Re: Initial Submission Review – Quiktrip 4274 – Conditional Use and Site Plan
Application Number: **DA-2373-00**
Case Numbers: **2024-6009-00, 2024-6009-01**

Initial Submission Review

QUICKTRIP 4274
E. HOUSTON RD.
SITE PLAN
COUNTY OF ANNEAPOLIS, STATE OF MARYLAND
GRADING & UTILITY PLAN

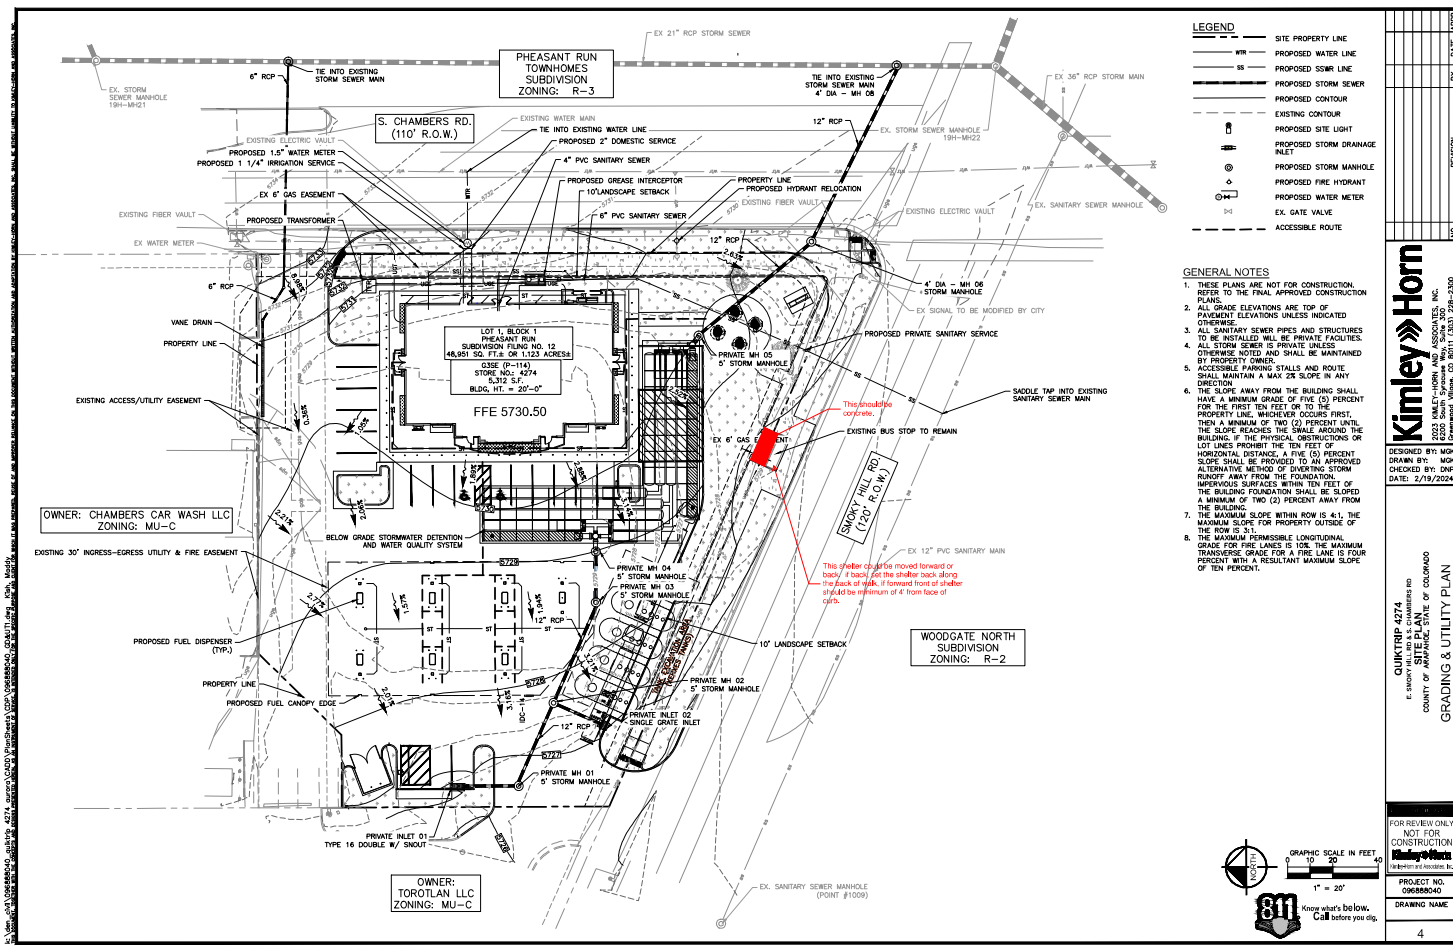
14B. Please specify as wet tap with size if necessary

14C. Please label sizes and materials of existing sanitary, storm, and water mains.

14D. 1.5" meter and tap already exist for this site. Please indicate that the old service will be abandoned and capped at the main if it is not being reused

14E. Please show proposed easements on this page.

14F. If existing sanitary service will not be used, please specify that it will be capped at the main.

14G. We recommend using the existing sanitary service for this site if possible.
